Date: May 22, 2019
To: Design Review Board
From: Scott Guter, AICP, Associate Planner
File No.: DRV16-02450
Subject: **434 KIRKLAND WAY MIXED USE PROJECT
MODIFICATION TO DRB DECISION**

**434 KIRKLAND WAY
MIXED USE
DRV16-02450**

DESIGN REVIEW MODIFICATION

SW PLAZA ON KIRKLAND WAY

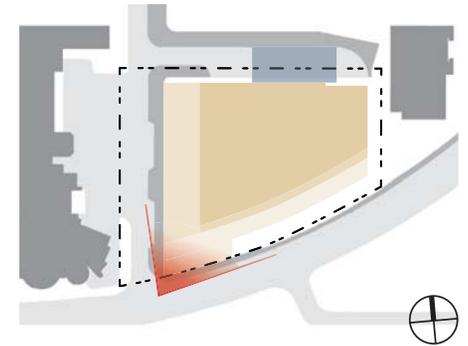
- A. Is the revised plaza design consistent with the design guidelines for plazas (see Attachment 3, pages 5, 7 and 21)? If not, what are several design techniques that can be utilized to address this issue?

- B. The new entry does not appear prominent when viewed from Kirkland Way. The associated canopy and its height relative to the grade along Kirkland Way appear shortened and should be discussed. Are these features as viewed from Kirkland Way consistent with pedestrian-oriented design guidelines (see Attachment 3, pages 5, 7 and 21)? If not, what are several design techniques that can be utilized to address this issue?

- C. Is the revision to the south exterior 'blank' wall facing Kirkland Way and adjacent to the plaza adequately mitigated (see Attachment 3, pages 3 and 25)? If not, what are several design techniques that can be utilized to address this issue? This wall is immediately adjacent to a major pedestrian thoroughfare and is highly visible.

The treatment of massing and modulation was an important discussion in the design review board approval process. The proposed modulation of the building remains similar to the approved design. Primary changes include:

- Along the west side of the building the tenant loading dock and the parking access drive have been added and the bay elements above the retail base have been modified with a more regular rhythm.
- The primary residential entry has been moved from the SW corner plaza to the south side of the building allowing the plaza area to be available for the retail tenant.

VIEW OF SW PLAZA

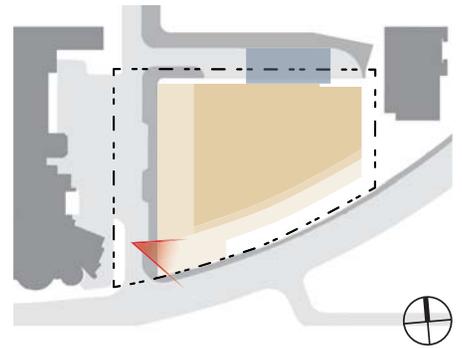
A PORTION OF THE PLAZA LOWERED 2'-6" TO ACCOMMODATE TENANT LAYOUT AND RAMP AND STAIRS ADDED FOR TRANSITION TO TENANT ENTRY

VIEW FROM NW CORNER

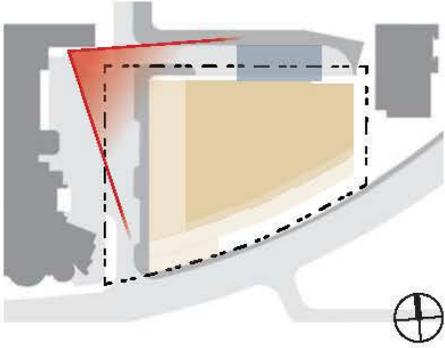
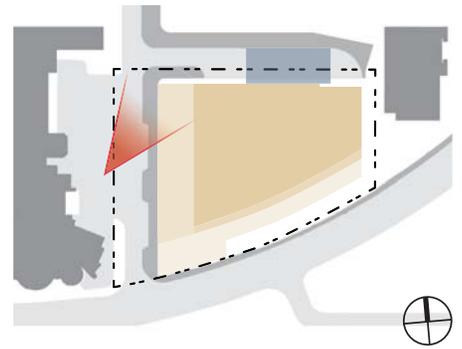
- D. Are the revisions along the west elevation facing the Park Promenade, including the loading area design, the adjacent blank wall treatments, i.e. the proposed canopy, seating and artwork (or historic graphics) and green screens, and surrounding landscaping adversely impacting this Major Pedestrian Sidewalk and the features originally approved by the Board (see Attachment 3, pages 9, 11, 21 and 25)? If so, what are several design techniques that can be utilized to address this issue? At issue, is whether the changes are adequate in mitigating blank walls and how the proposed changes relate to each other and the overall design of the façade.

WINDOW PLACEMENT ADJUSTED TO ACCOMMODATE UNIT FUNCTION

REFINED EYEBROW DETAILING AND REDUCED DEPTH

ADDED EQUITONE ACCENT PANELS AT WINDOWS

ADDED BALCONY FOR UNIT ENHANCEMENT AND TO MATCH SOUTH TOWNHOME

EQUITONE ACCENT PANELS REFINED

BALCONY RAILINGS OMITTED FROM LOWER LEVEL UNITS

ADDED LIGHTING LOCATIONS

REFINED EQUITONE ACCENT PANELS AT BAYS

ADJUSTED BAY PLACEMENT AND FACADE CONFIGURATION TO ACCOMMODATE ANCHOR TENANT STOREFRONT, PARKING ACCESS AND LOADING AREA

UPDATED CANOPY DESIGN TO MEET STRUCTURAL REQUIREMENTS

CANOPY, SEATING AND ARTWORK OR HISTORIC GRAPHICS TO ENHANCE THE PEDESTRIAN EXPERIENCE

PENTAL STONE PANELS IN LIEU OF GFRC PANELS AT BASE OF RETAIL AND TOWNHOME BAYS

CONFIGURATION OF GREEN SCREENS AND LOUVERS UPDATED FOR REVISED PARKING AND DRIVEWAY LAYOUT

OMITTED VEHICLE ACCESS AS REQUIRED BY ADJACENT PROPERTY OWNER - REPLACED WITH GREEN SCREEN FEATURES

REVISED STAIR TOWER EXTERIOR FINISH WITH EQUITONE VERTICAL SLATS

LANDSCAPING FOR BLANK WALL TREATMENT

LOUVERS TO ACCOMMODATE ANCHOR TENANT EQUIPMENT REQUIREMENTS

LOADING AREA PER ANCHOR TENTANT REQUIREMENTS FINISHED WITH HORIZONTAL EQUITONE SLATS OVER 5' HIGH CONCRETE WALL

VIEW FROM EMERALD OFFICE BUILDING

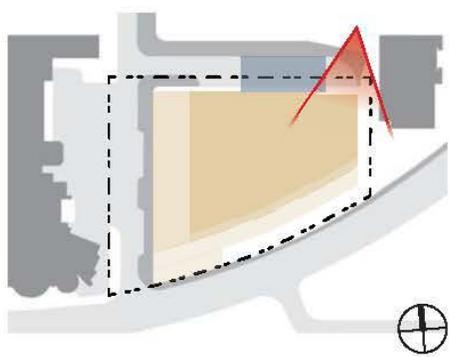
- E. The north facing podium level adjacent to the shared driveway with Kirkland Urban has increased in size and bulk and its landscaping has been reduced. Are the proposed green screens and landscaping enough to soften the revised massing (see Attachment 3, pages 13 – 15, 21 and 27)? If not, what are several design techniques that can be utilized to address this issue?

REDUCED EYEBROW DEPTH
 WINDOW SIZES AND CONFIGURATIONS UPDATED, TYPICAL, FOR ENERGY CODE COMPLIANCE AND DESIGN CONSISTENCY

OMITTED BALCONIES AND RAILINGS AT LOWER LEVELS

EQUITONE COLORS REVISED WITH DARK COLOR AT VERTICAL AND RED AT HORIZONTAL FOR DESIGN CONSISTENCY

ADDED UNIT VENTING LOCATIONS, TYP

EQUITONE ACCENT COLORS REVISED TO EMPHASIZE HORIZONTAL

EXIT STAIR TOWER ADDED WITH EQUITONE SLAT FINISH

PARKING ACCESS OMITTED

GARAGE ACCESS REVISED

METAL PANEL ACCENT FINISH

CONFIGURATION OF GREEN SCREENS AND LOUVERS UPDATED FOR REVISED PARKING AND DRIVEWAY LAYOUT
 CURB LOCATION AND LANDSCAPING REVISED

ADDED LIGHTING ALONG NORTH WALL
